ZONING BOARD OF APPEALS
CITY OF NOVI
Community Development Department
(248) 347-0415

Case No. 12-011 Collex Collision

Location: 25100 Novi Road

PLAN REVIEW CENTER REPORT
March 28, 2012
Planning Review for Zoning Board of Appeals
Collex Collision
SP 12-03

Proposed Facilities

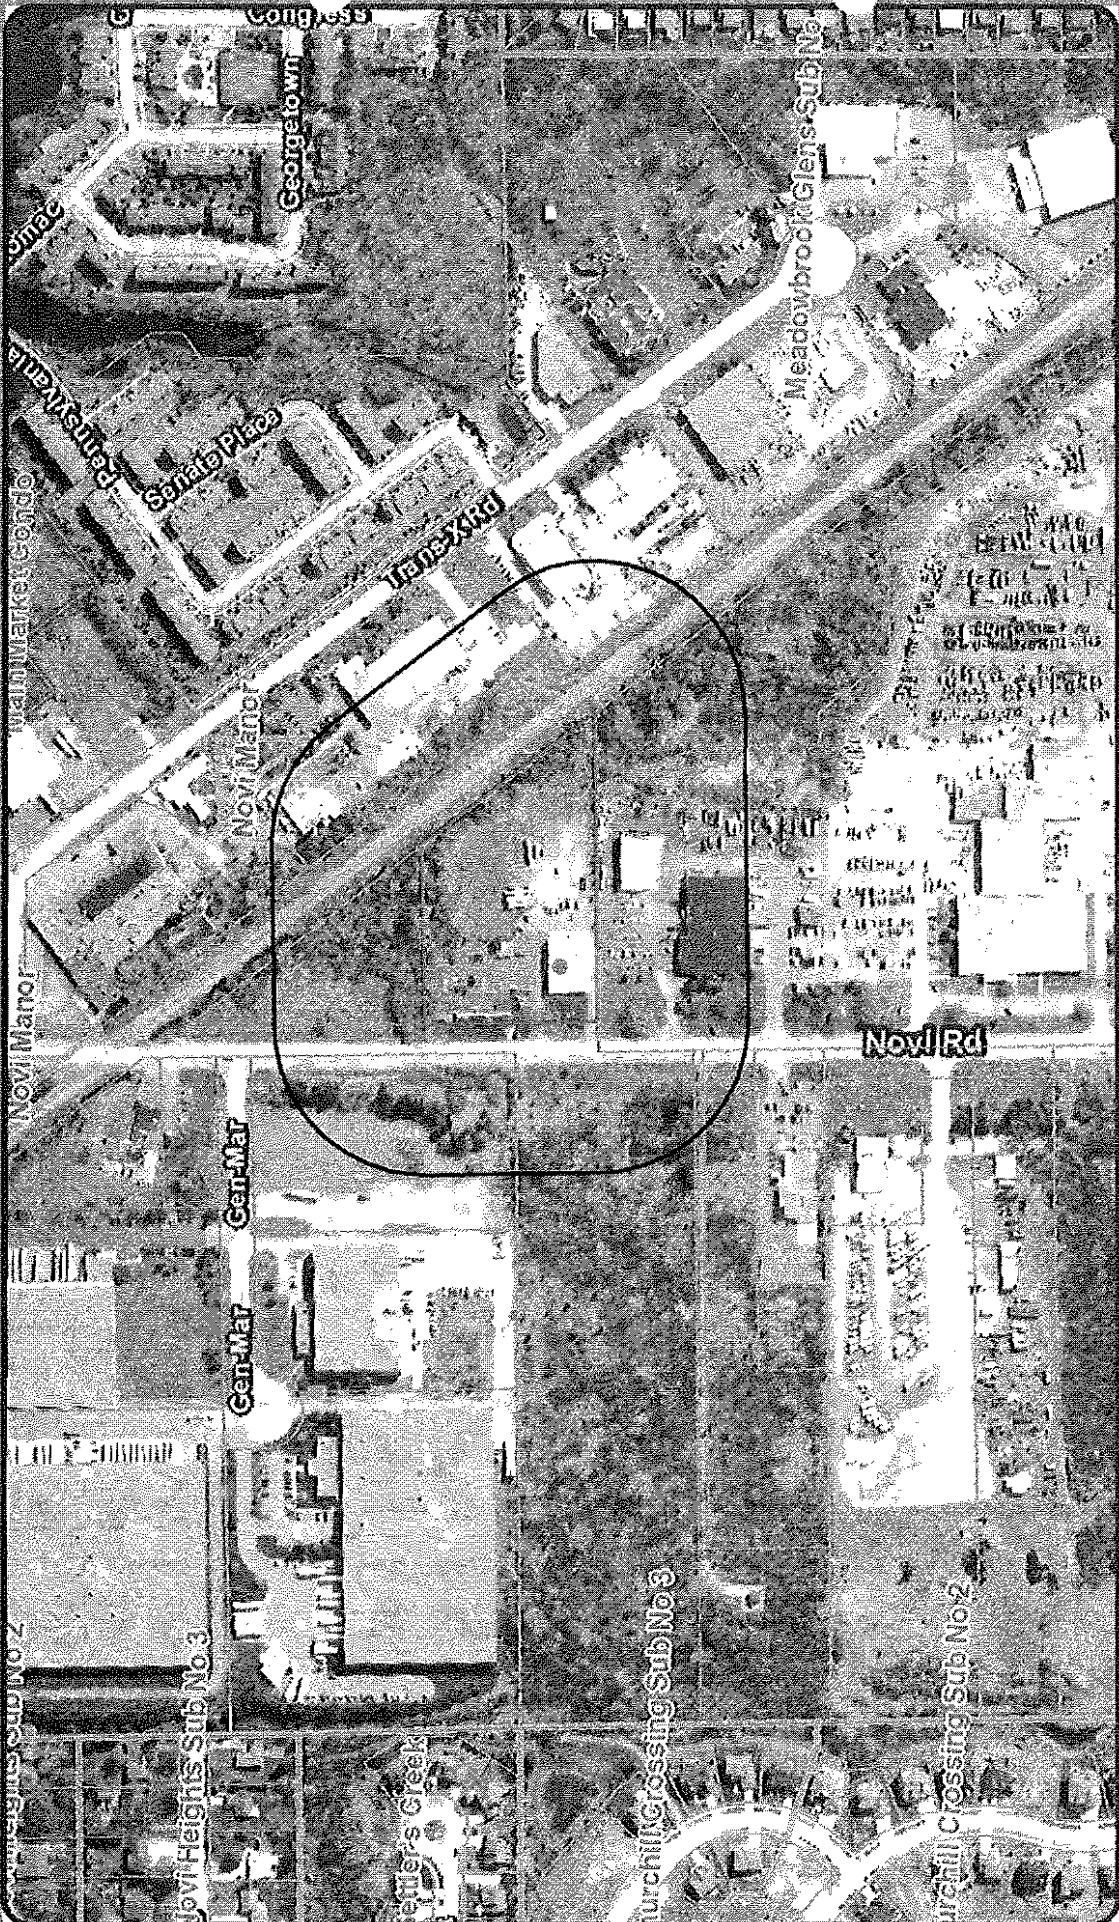
C. Section 2505. The variance requested is for the number of parking spaces which would be required by a strict interpretation of the Zoning Ordinance. The staff has calculated we need 220 spaces for our new building and 80 spaces for the existing building which total 300 spaces for our entire site. We believe the Ordinance is ambiguous on its face. Please refer to **Exhibit A** which is the City's Ordinance definition of "Floor Area, Usable". As you can see in **Exhibit A**, the normal definition deals with the floor area which used to be used for the sale of merchandise or services or for the use to service patrons, clients or customers. The Ordinance then excludes areas principally used for storage, processing of merchandise, hallways or for utilities or sanitary facilities. Thereafter, someone thought it necessary to add an additional sentence dealing with automobile service establishments. It states: "Floor space to be used for servicing vehicles in automobile service establishments and public garages shall be considered as usable floor space."

As you can see in **Exhibit B**, the usable floor space for servicing of vehicles in our new building equals 10,191 square feet. The City Staff is calculating the usable floor space as the entire building. The Applicant would propose the City amend its off-street parking requirements for automobile repair facilities and garages to more closely reference what occurs in reality.
